**THE CAMBOURNE TO CAMBRIDGE ORDER**

**REBUTTALS - APPENDICES**

# **Cambourne to Cambridge (CtoC) Scheme**

Further Assessment of CPPF Alternative Scheme

MADINGLEY ROAD CPPF NEARSIDE BUS  
LANE CONCEPT DESIGN CROSS SECTIONS  
(SHEET 1 OF 4)

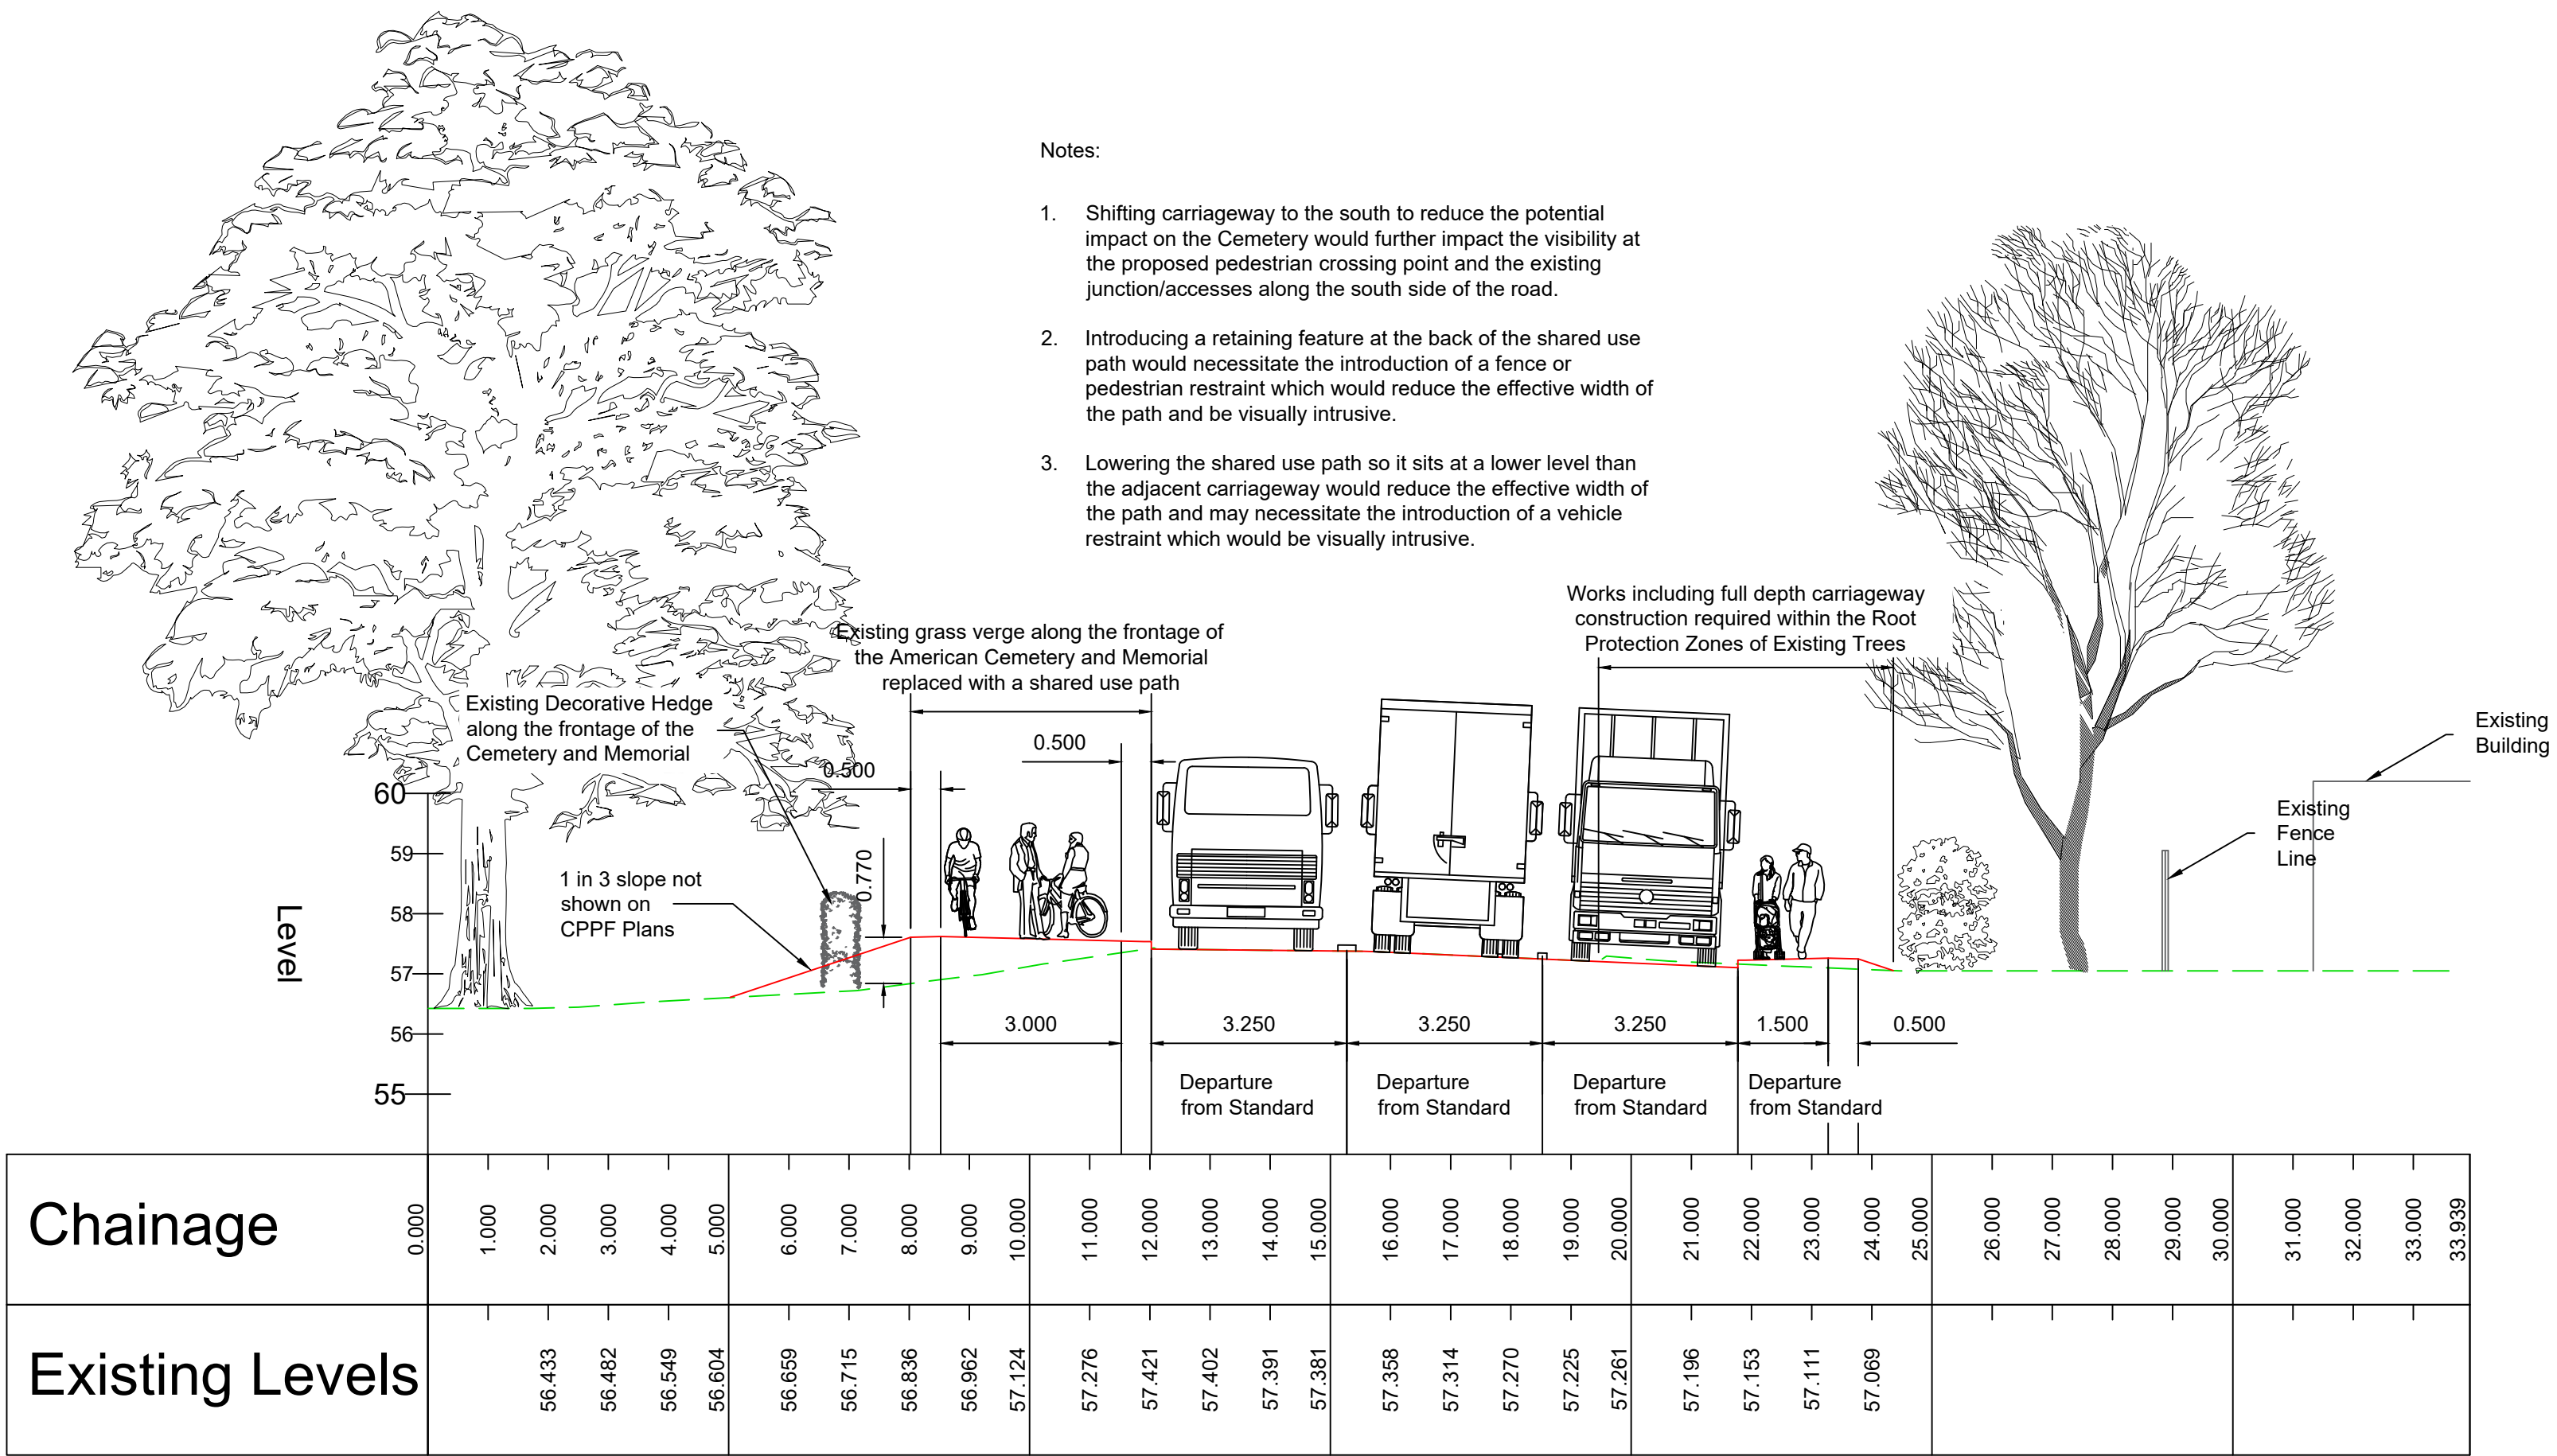
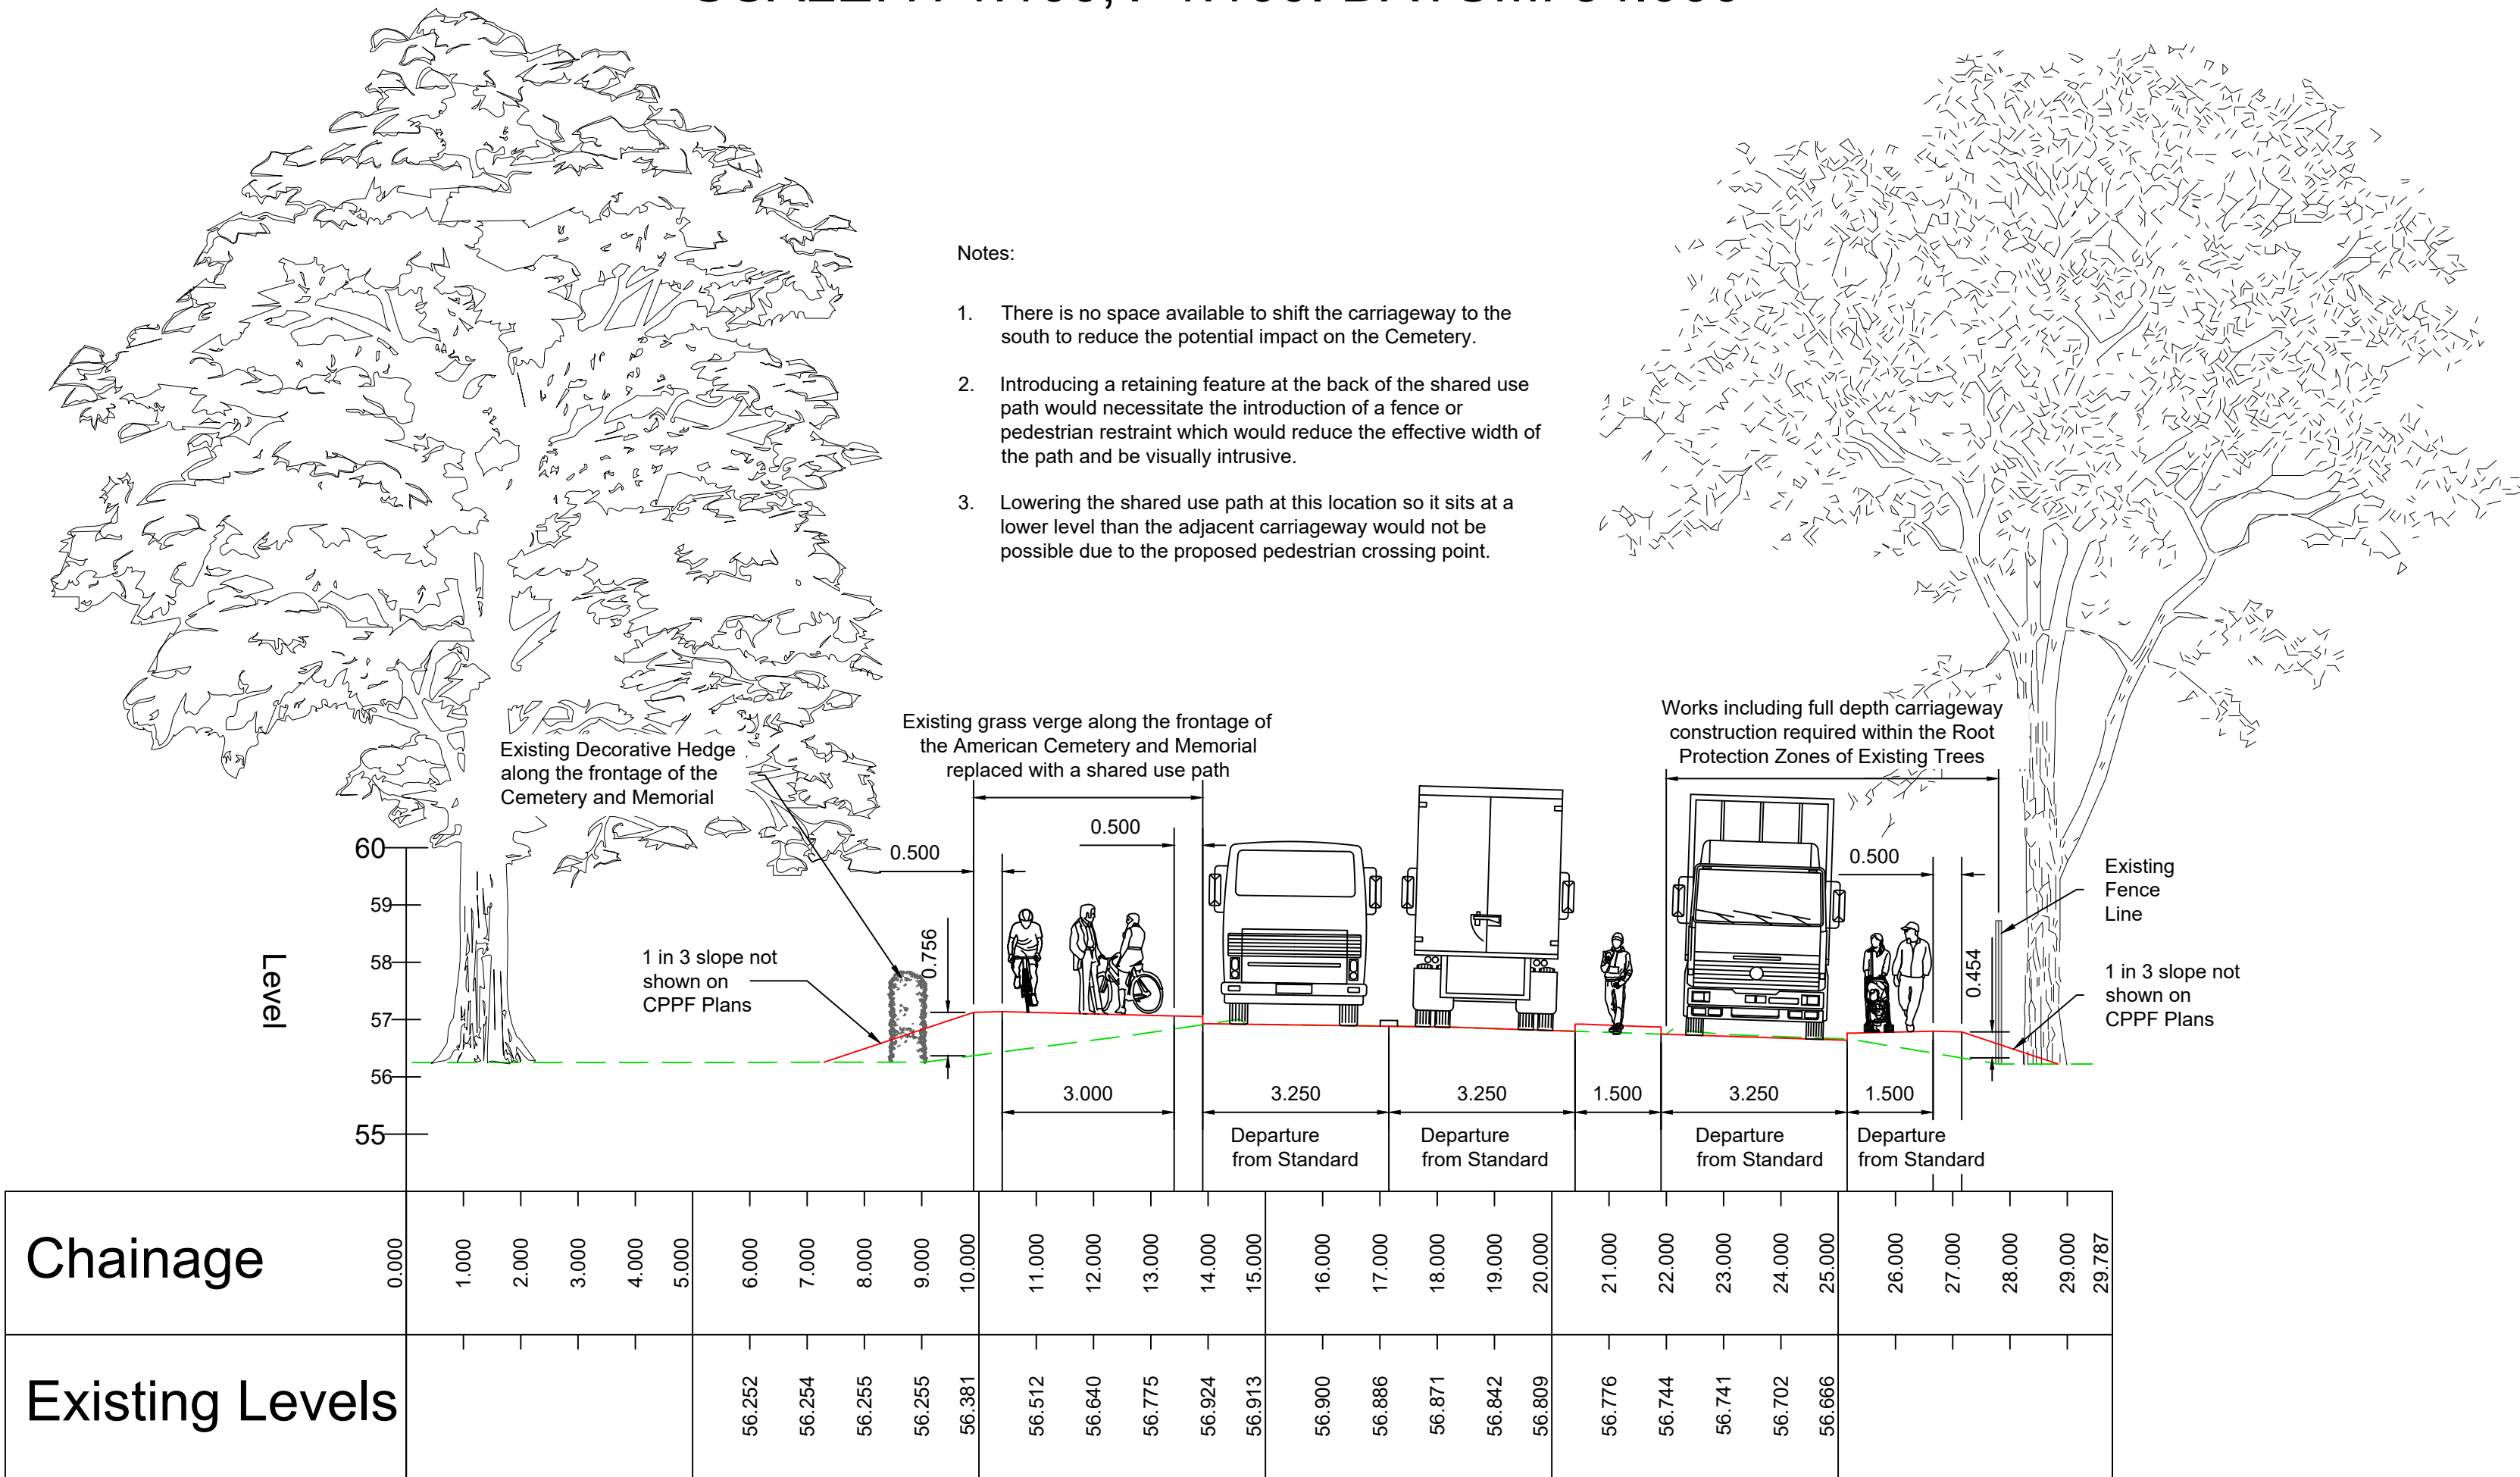
- Cross sections are based on the CPPF Proposed Scheme Layout (Civilistic Drawings C-001, C-002, C-003).
  - A 0.5m verge/berm has been added to the cross sections (not shown on CPPF drawings) to:

- Provide a safety buffer between the path edge and any slopes, helping maintain effective path width near vertical features.
  - Where level differences exist, a 1:3 slope has been included to tie into existing ground levels.
